City of San Antonio

ADDENDUM No. 1

PROJECT NAME: Citywide Bridge Replacement - Shaenfield Road

DATE: March 4, 2014

PROPOSED TYPICAL SECTION
STA 30+90 - STA 39+95
N.T.S.

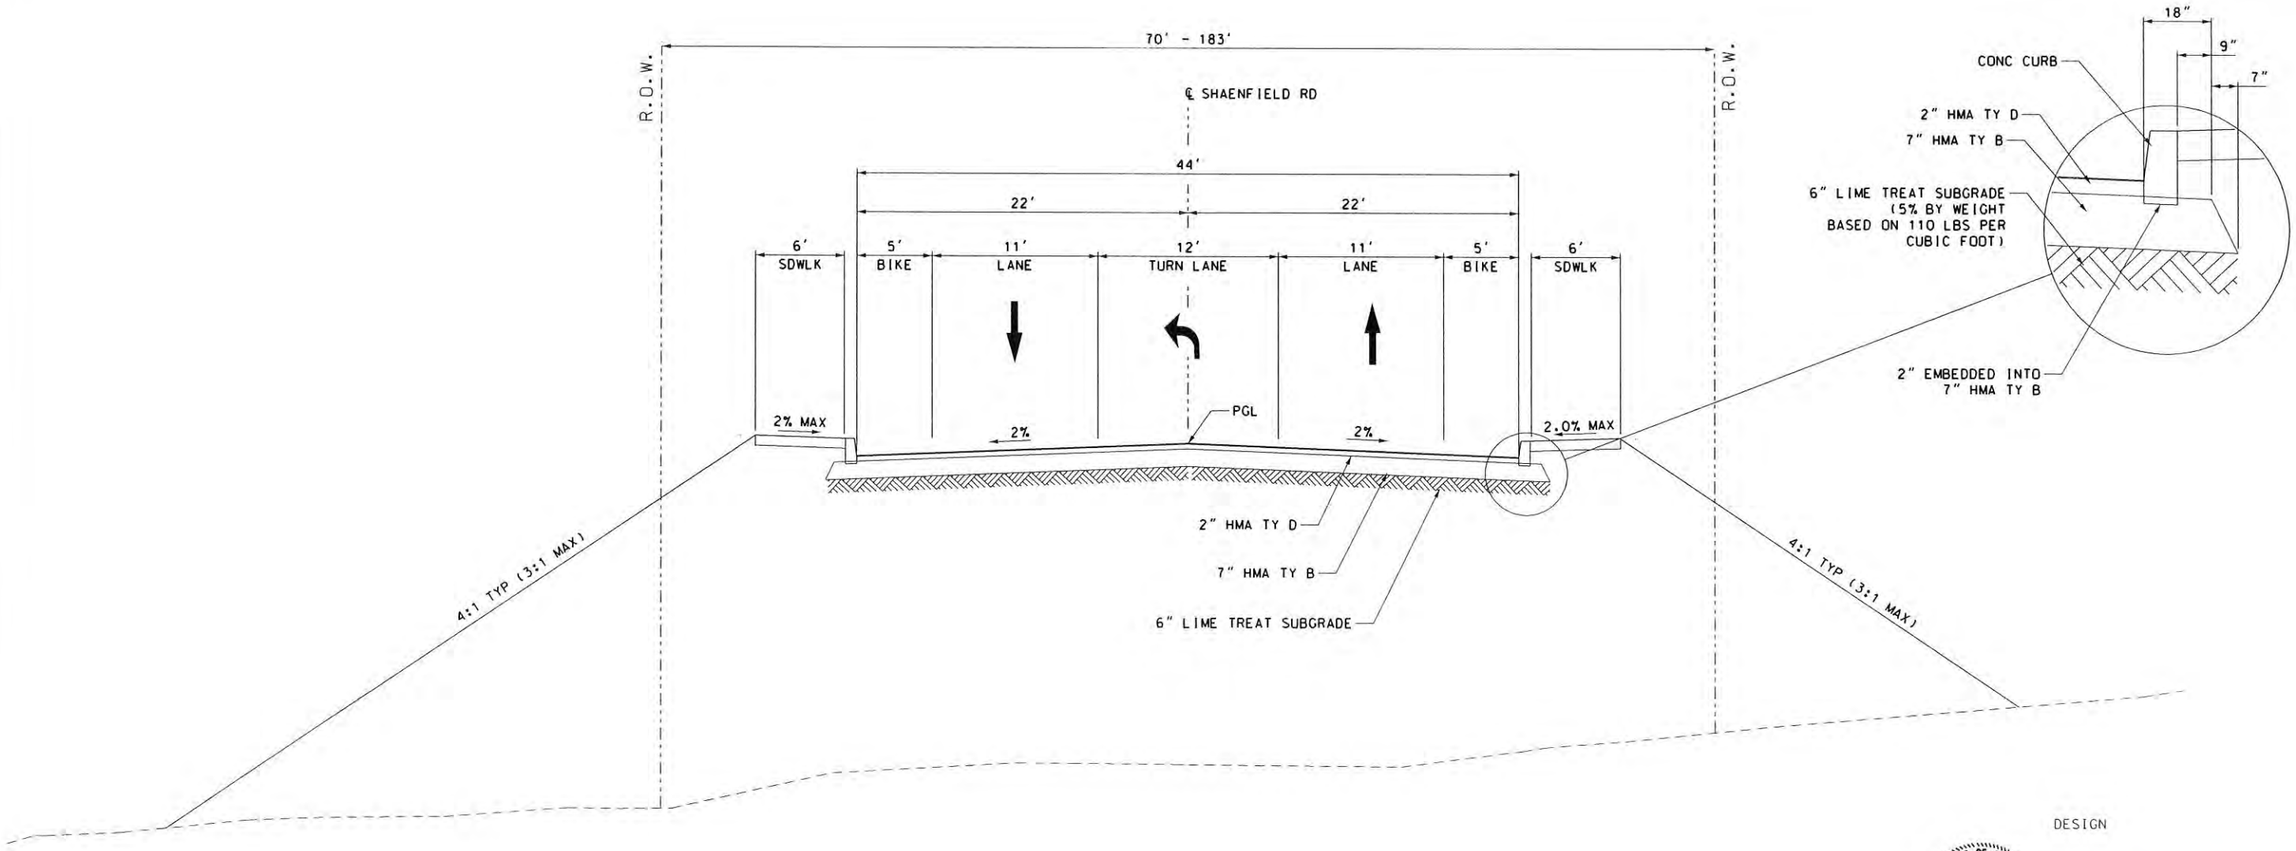
C. Remove sheet no. 6, TYPICAL SECTION, and replace with revised sheet no. 6. Revisions include:
   a. Added note

NOTE: MACHINE LAY IS PRIMARY METHOD FOR TY B PLACEMENT. BLADE LAY IS ONLY BY ENGINEER'S APPROVAL.

100 % SUBMITTAL	PROJECT NO. 40-00294		DATE FEB 2014
DRWN BY LR	DSGN BY: LR	CHKD BY: JL	SHEET NO 22 OF 137

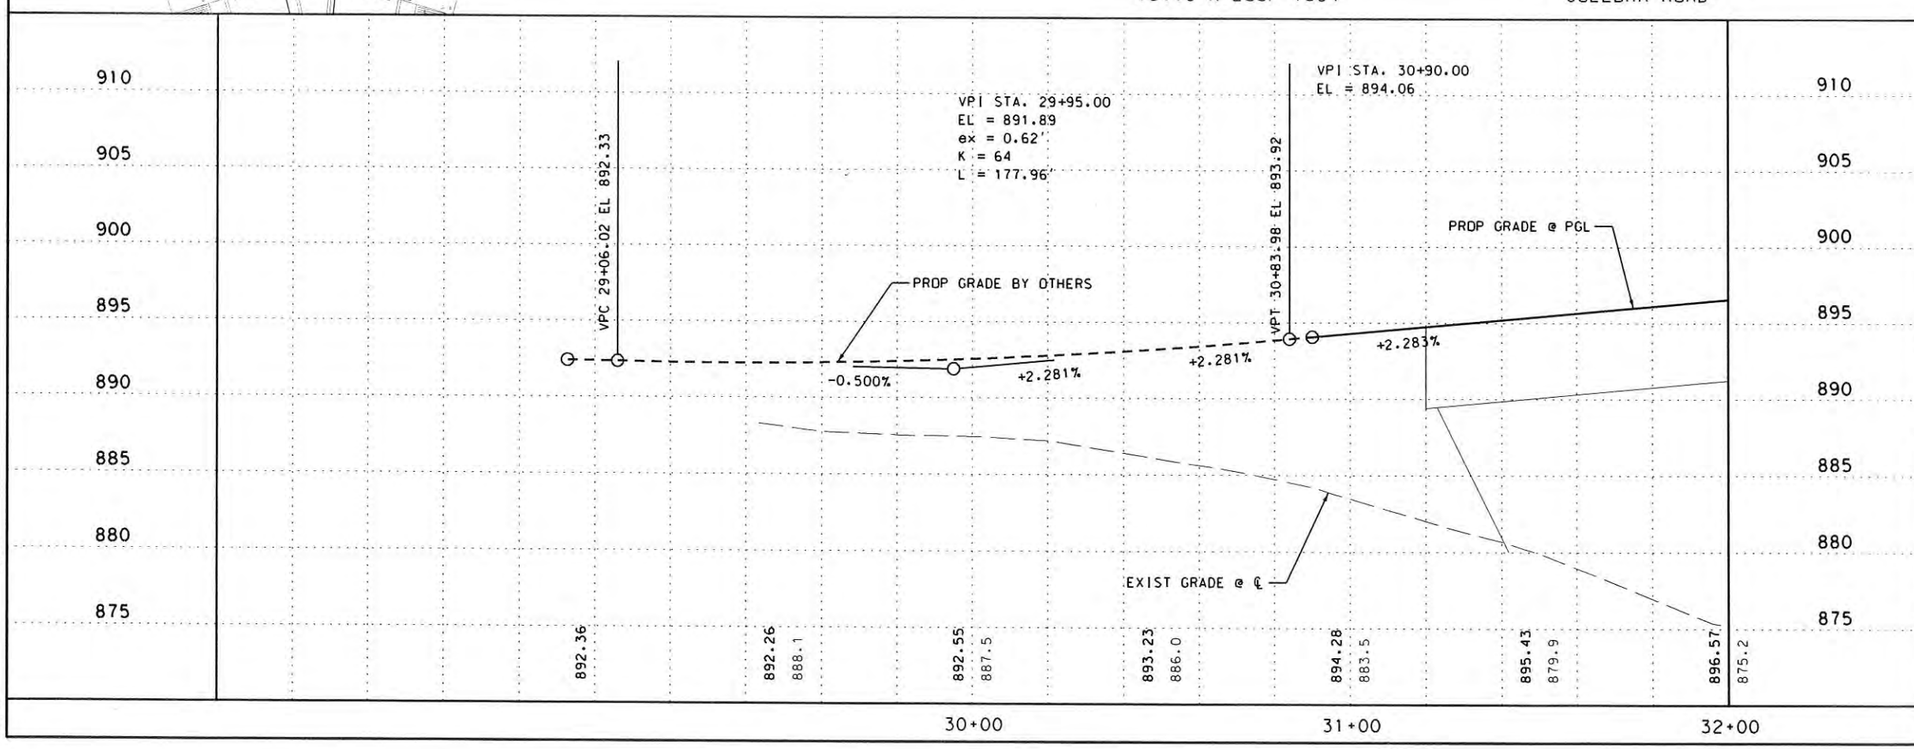
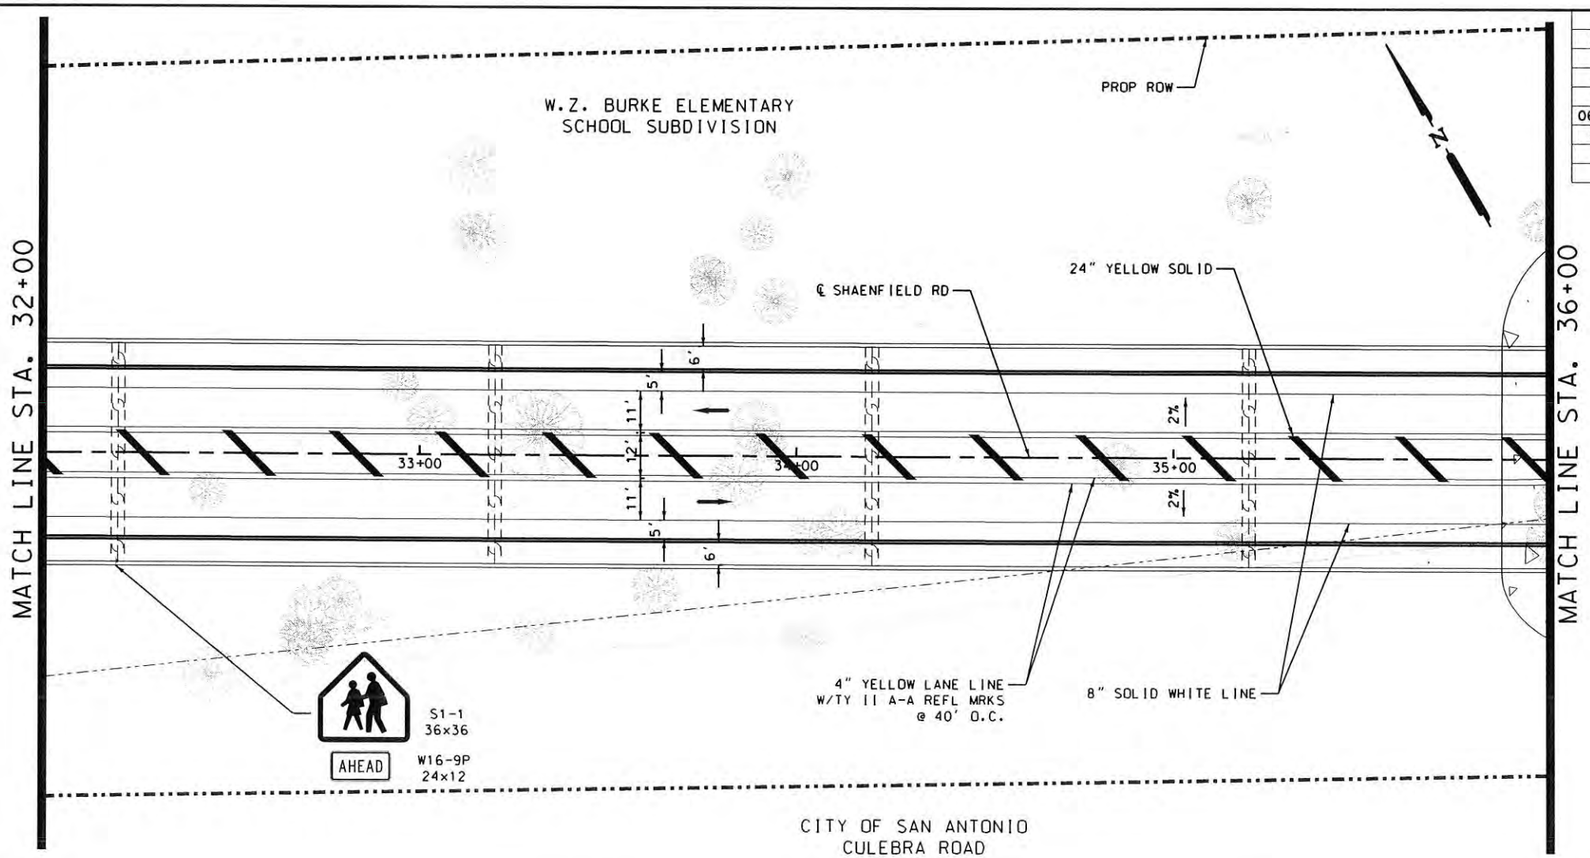
E. Remove sheet nos. 22-25, PLAN & PROFILE SHEET, and replace with revised sheet nos. 22-25. Revisions include:
   a. Revised ROW line
   b. Revise pedestrian ramp

100% % SUBMITTAL | PROJECT NO. 40-00294 | DATE 2-28-2014
DRWN. BY JTM | DSGN. BY: JTM | CHKD. BY: TLC | SHEET NO. 35 OF 137

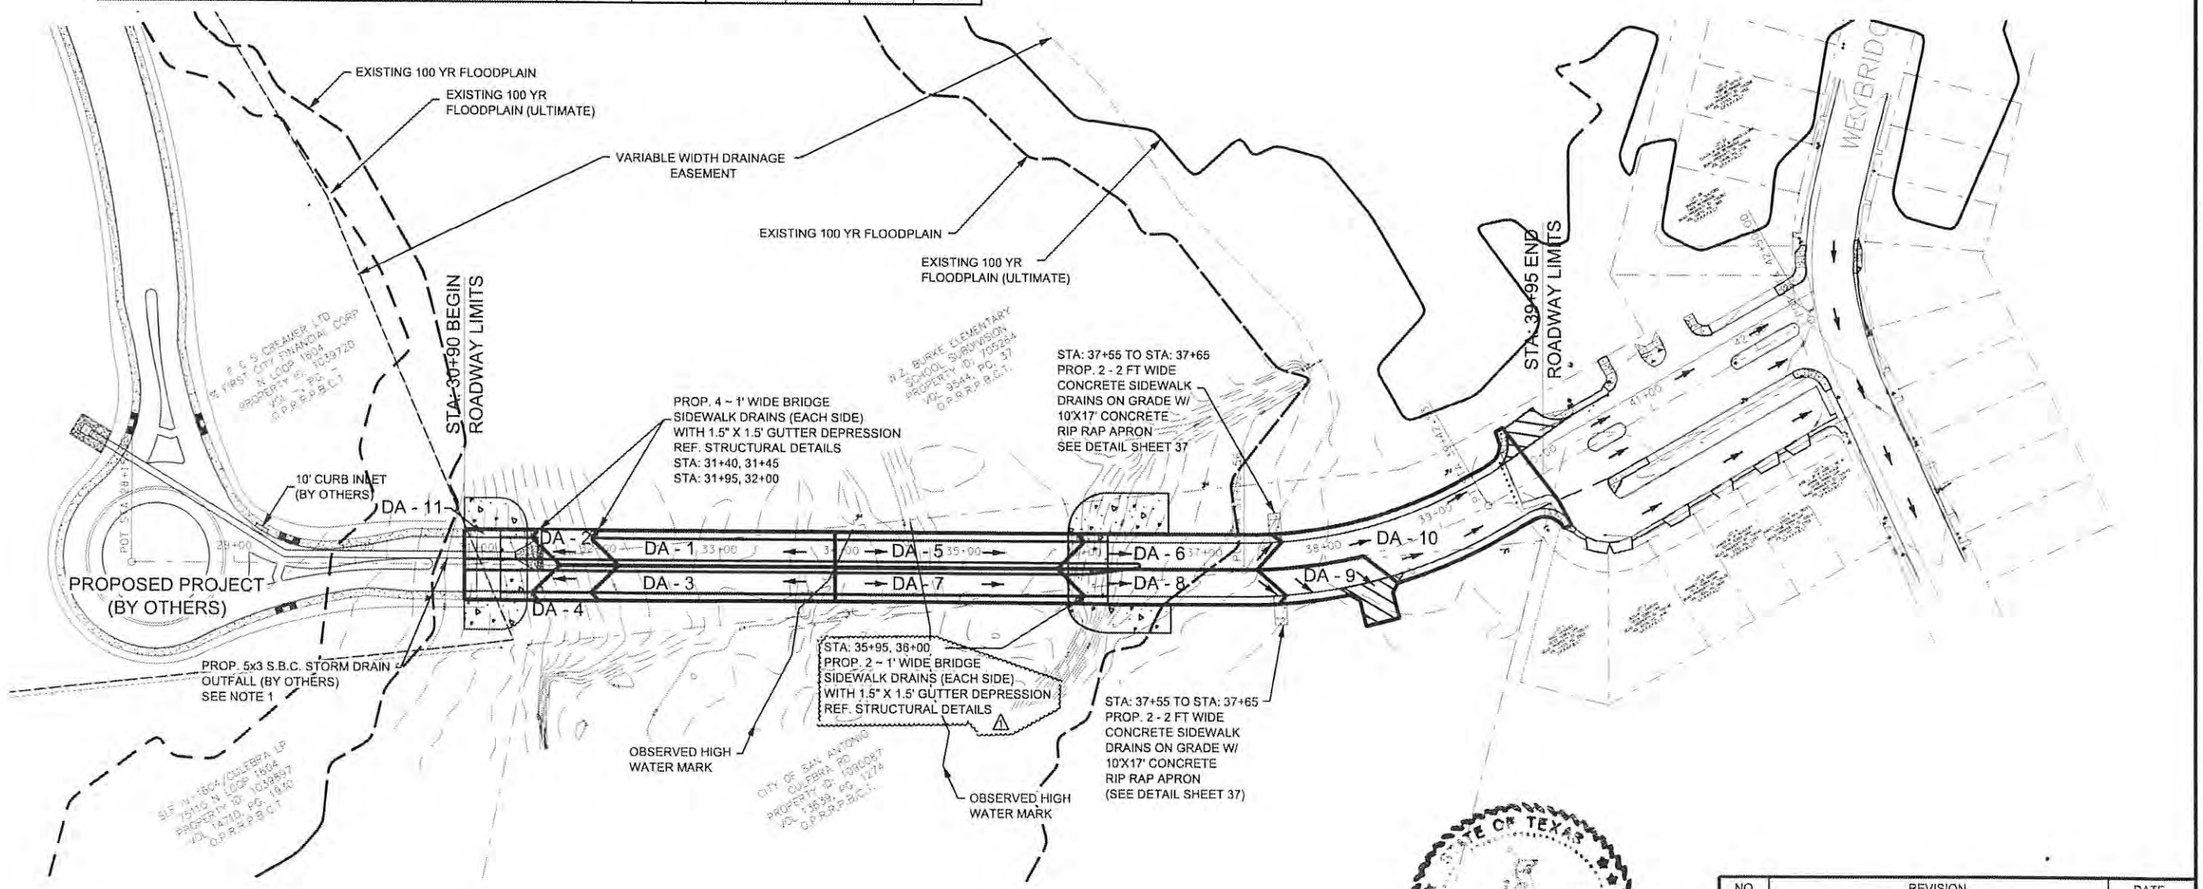
F. Remove sheet no. 35, PROPOSED DRAINAGE AREA MAP, and replace with revised sheet no. 35. Revisions include:

a. Revised number of bridge sidewalk drains
b. Revised quantity of metal for bridge sidewalk drains

NO.	REVISION	DATE
△1	REVISED QUANTITY FOR BRIDGE SIDEWALK DRAINS	2-28-14

100 % SUBMITTAL	PROJECT NO. 40-00294		DATE 2-28-2014
DRWN BY: JTM	DSGN BY: JTM	CHKD BY: TLC	SHEET NO 132 OF 137

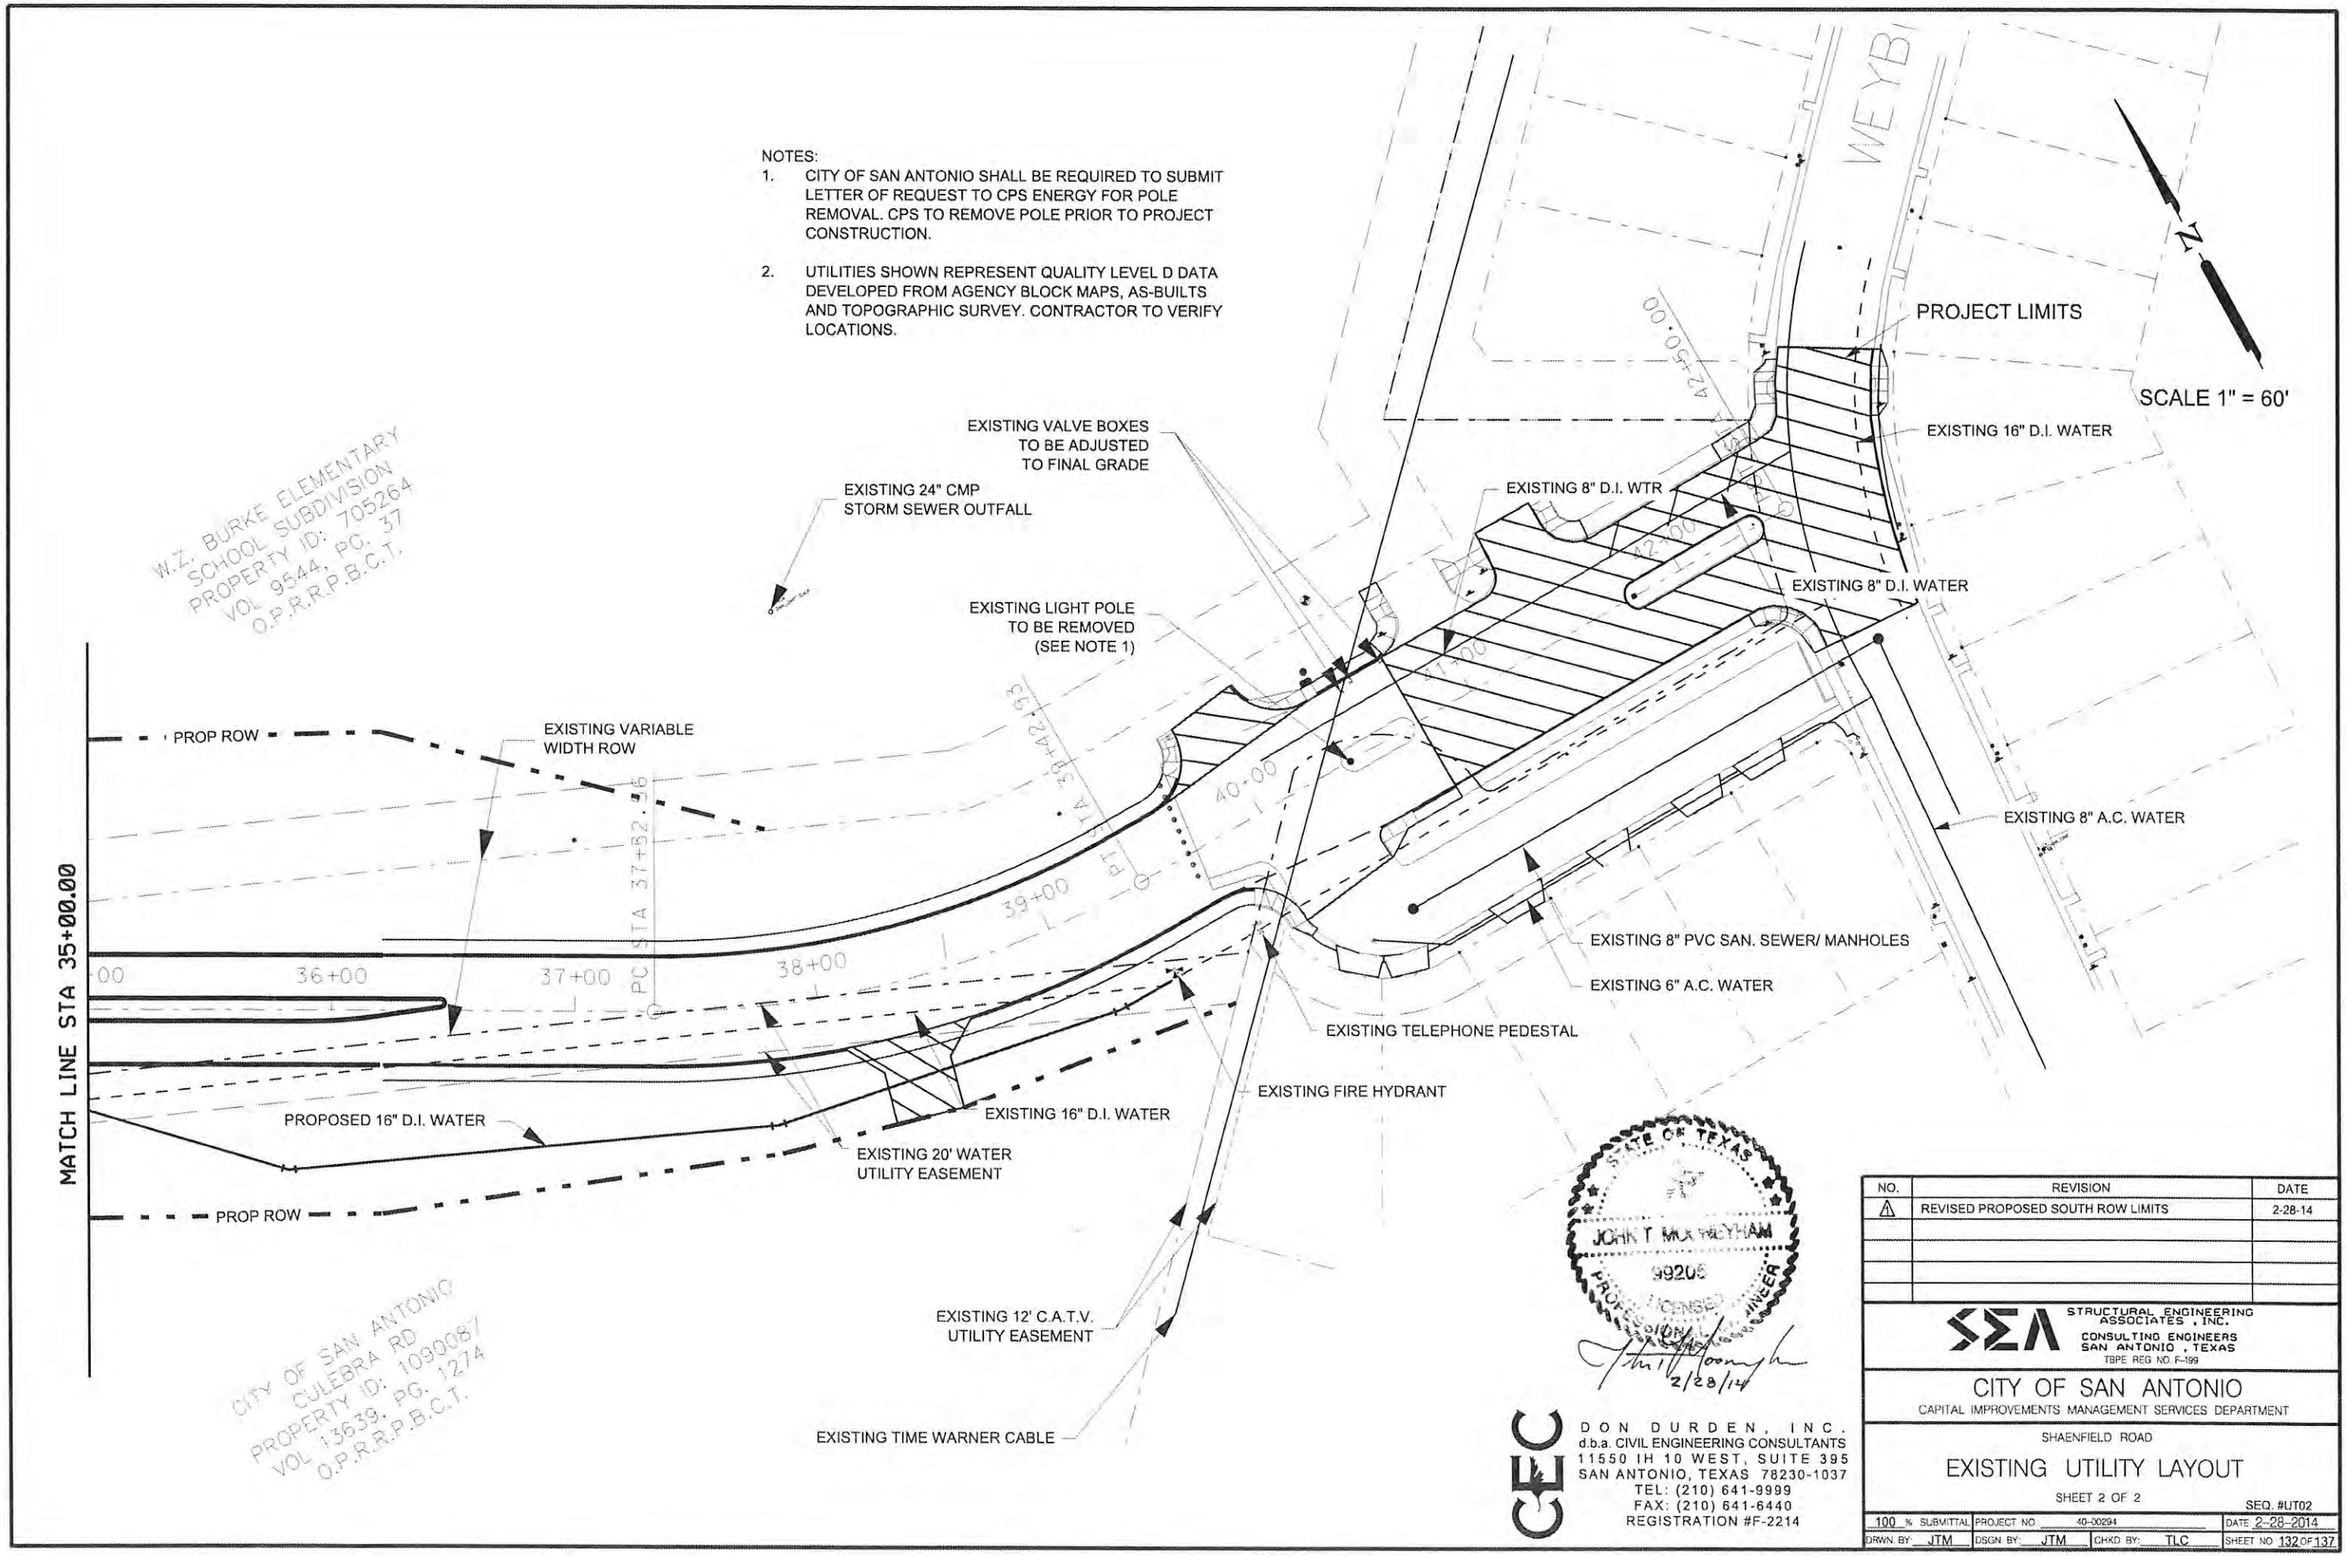
G. Remove sheet no. 132, EXISTING UTILITY LAYOUT, and replace with revised sheet no. 132. Revisions include:

a. Revised proposed south ROW limits

NO.	REVISION	DATE
1	REVISED PROPOSED SOUTH ROW LIMITS	2-28-14
